**Before the
Federal Communications Commission
Washington, DC 20554**

In the matter of)
)
Service Rules for the 746-764 and 776-)
794 MHz Bands, and Revisions to Part) WT Docket No. 99-168
27 of the Commission's Rules)
)

**Petition for Reconsideration by
The National Public Safety Telecommunications Council**

Protection of Public Safety Systems from 700 MHz CMRS Band Interference

Figure1, A 100 ft tower utilizing a 9 dBd omni-directional antenna

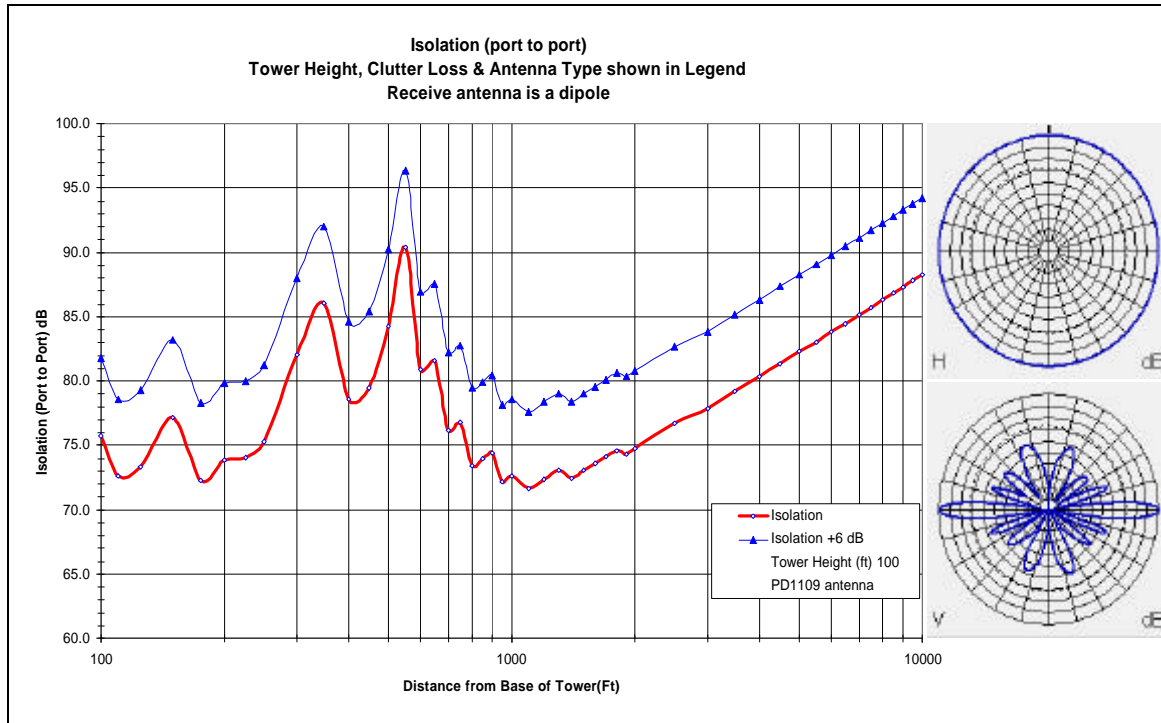
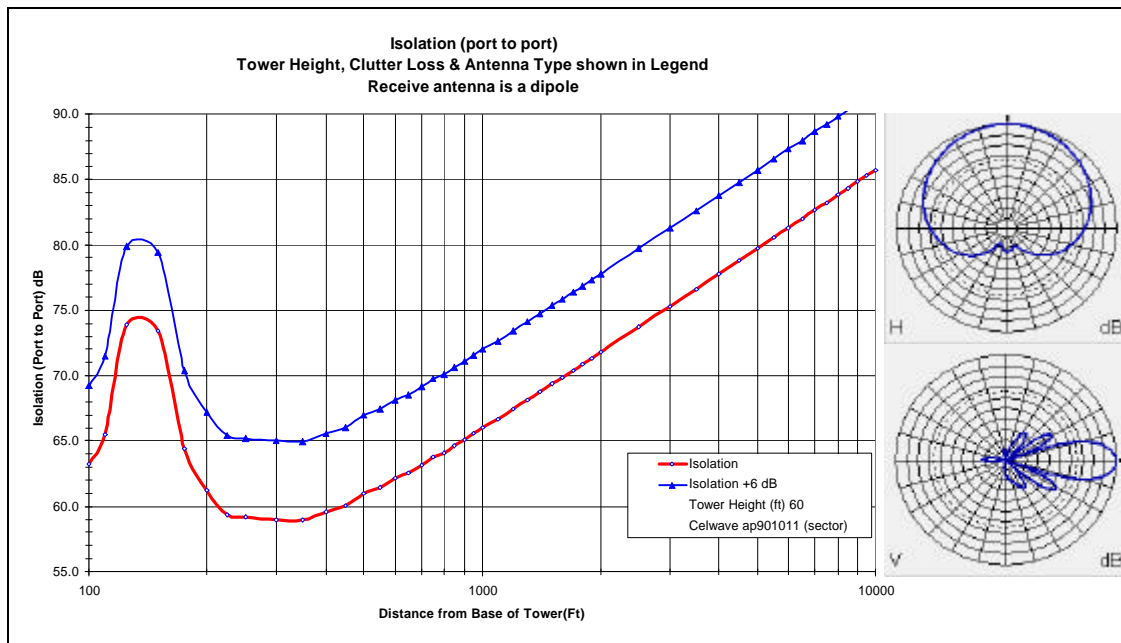
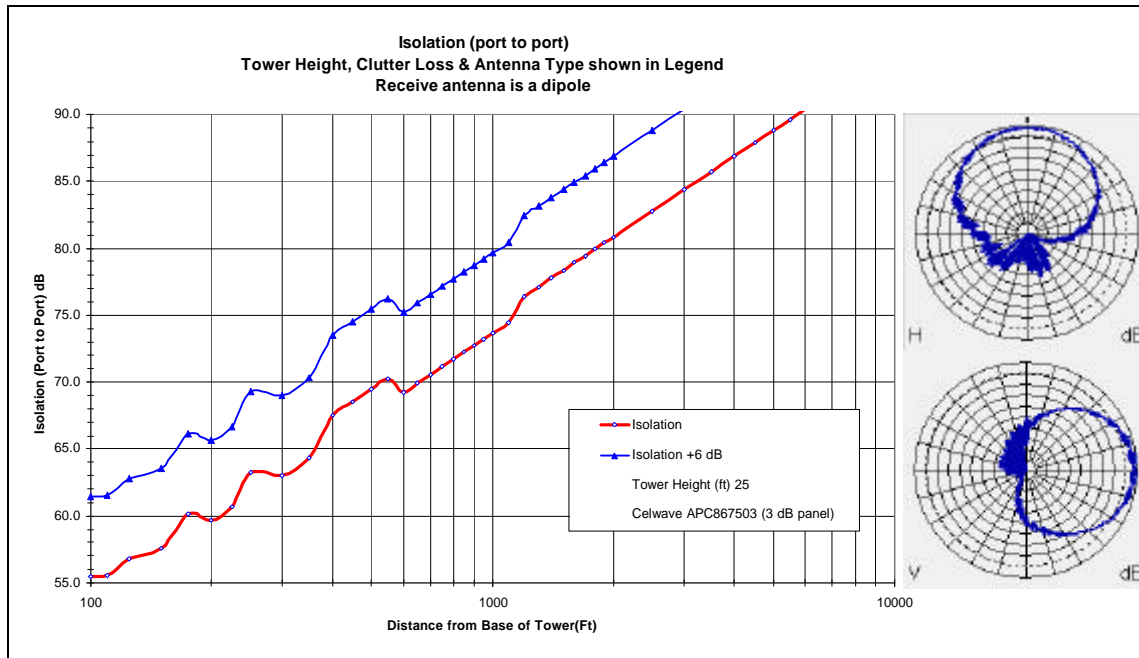
As can be seen from the baseline of Figure 1 and the newer deployments of Figure 2 and 3, there is definite erosion from the historic 75 dB isolation value. With shorter towers being deployed the loss of isolation is even greater. With a 60-foot tower, the isolation drops to 60 to 65 dB. Microcell deployments in major metropolitan regions have already been observed and in this region the isolation drops below 60 dB. The jaggedness of the graphs is due to the antenna pattern resolution.

Note that in Figure 2, a sectored antenna's wide beamwidth eliminates many of the variations of the omnidirectional antenna in Figure 1. The wider beamwidth reduces the port-to-port isolation.

Figure 4, Base to Base interference

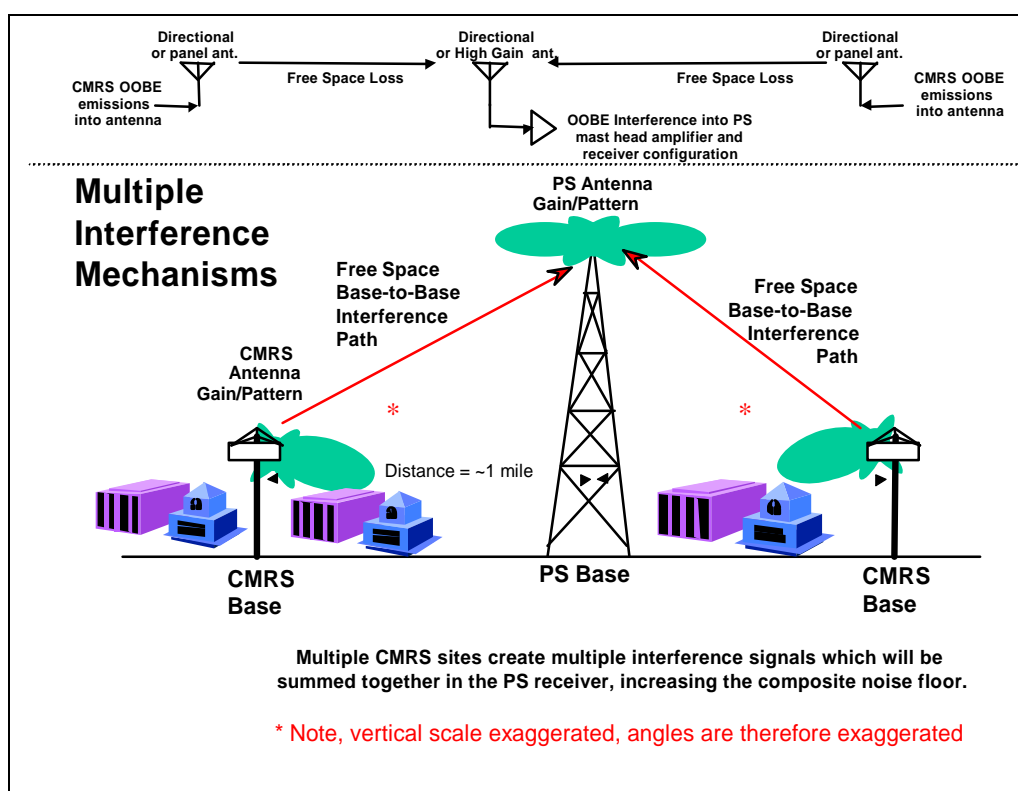
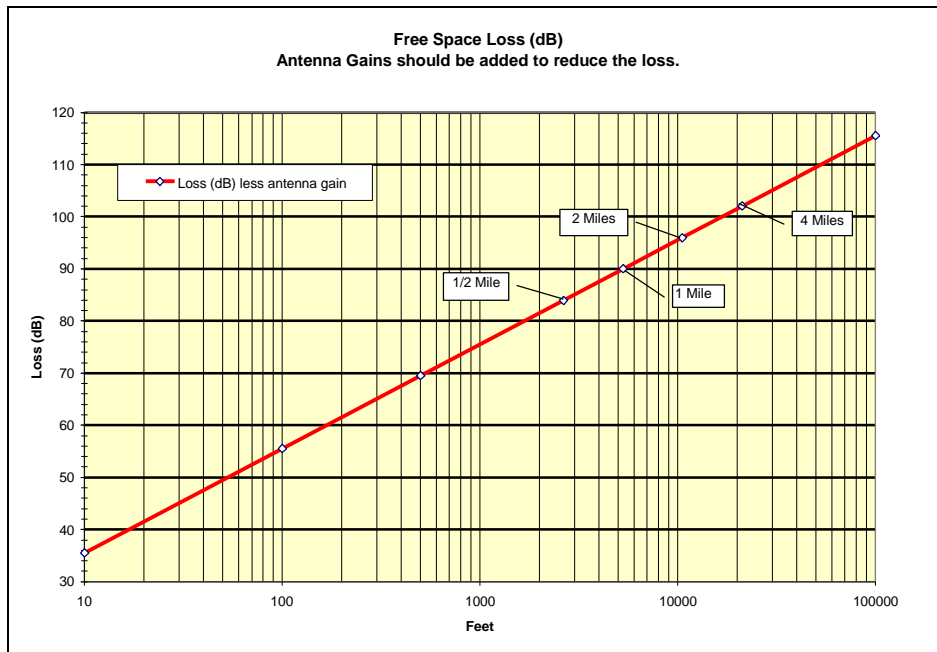
At one mile, Figure 4 and 5, free space loss equals 90 dB. Free space loss requires approximately 24 feet clearance at the midpoint of a one-mile path. This is easily achieved with CMRS tower or deployment on building tops or their sides. Public safety towers are generally tall so they are above the local environmental clutter. The CMRS antennas were historically above the local clutter as well.

Due to the large number of CMRS sites required for capacity, a site separation of 2 miles between CMRS deployments is assumed. Figure 4 illustrates that there will be two potential interferers if the Public Safety site is midway between the CMRS sites. The antenna patterns shown are not to scale and don't represent the wider vertical beamwidths currently being deployed. The exaggerated vertical scale makes the angles exaggerated. Angles are much less than Figure 4 would imply

This requires the OOB specification for transmitters in the upper portion of the CMRS band be increased to - 80 dBm into any 6.25 kHz channel in the upper portion of the Public Safety band, and -61 dBm into the lower portion of the Public Safety band.

Figure 6, Power variations as a function of separation

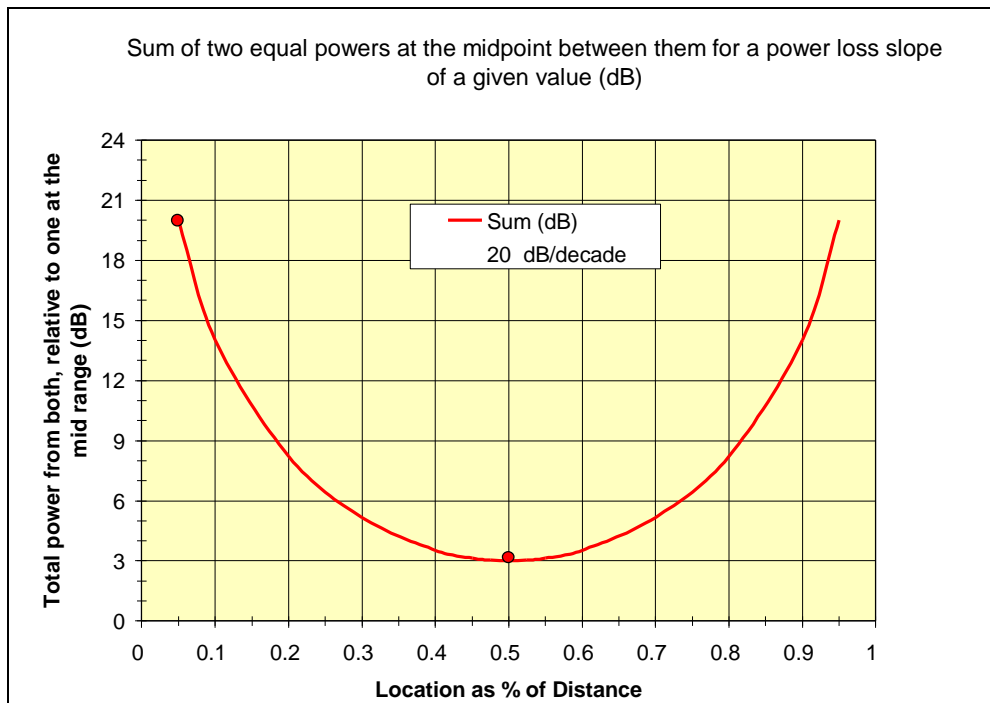
With shorter CMRS towers, there is a decreased likelihood of having the clearance for free space loss. However, as a site is moved from the midpoint toward one of the sites, one signal increases and has a higher likelihood of having the necessary clearance. Figure 6 shows that if one of the sites is moved so that it is 0.1 mile from the dominant interfering site, the free space loss is reduced by 20 dB (the interfering power is increased by 20 dB). When very close spacing occurs, the antenna gains are not as prevalent due to antenna discrimination. Therefore a reduction of ~20 dB represents a realistic scenario, especially when there will be voting receiver sites that frequently have lower antenna height than base transmitters. The voting receivers will be on the same frequency as the base receiver.

Figure 8 - Recommended CMRS Out of Band Emissions

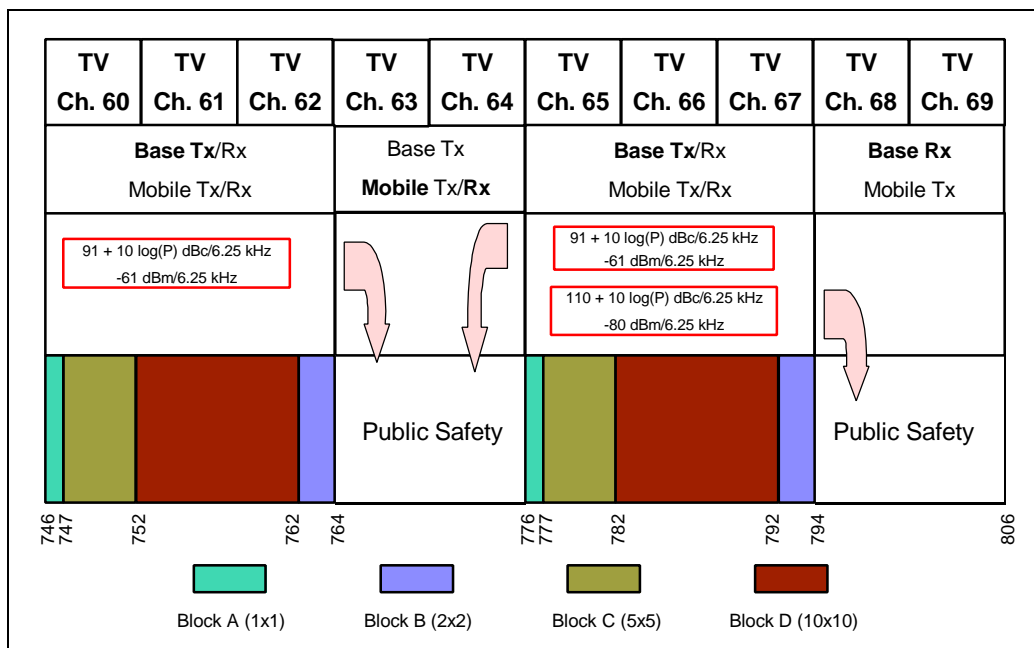
It is recommended that the FCC review the current recommendations for 47 CFR § 27.53 and incorporate these recommended values. It is further recommended that fixed stations comply with the base station requirements rather than mobile requirements as their interference potential is equivalent to that of a base station. Figure 8 graphically shows the recommendation.

§ 27.53 Emission limits.

(c) For operations in the 747 to 762 MHz band and the 777 to 792 MHz band, the power of any emission outside the licensee's frequency band(s) of operation shall be attenuated below the transmitter power (P) within the licensed bands(s) of operation, measured in Watts, in accordance with the following:

- (1) On any frequency outside the 747 to 762 MHz band, the power of any emission shall be attenuated outside the band below the transmitter power (P) by at least $43 + 10 \log (P)$ dB;
- (2) On any frequency outside the 777 to 792 MHz band, the power of any emission shall be attenuated outside the band below the transmitter power (P) by at least $43 + 10 \log (P)$ dB;
- (3) On all frequencies between 764 to 776 MHz and 794 to 806 MHz, by a factor not less than $110 + 10 \log(P)$ dB in any 6.25 kHz band segment, for base and fixed stations at any location;
- (4) On all frequencies between 764 to 776 MHz and 794 to 806 MHz, by a factor not less than $91 + 10 \log(P)$ dB in any 6.25 kHz band segment, for mobile and portable stations;
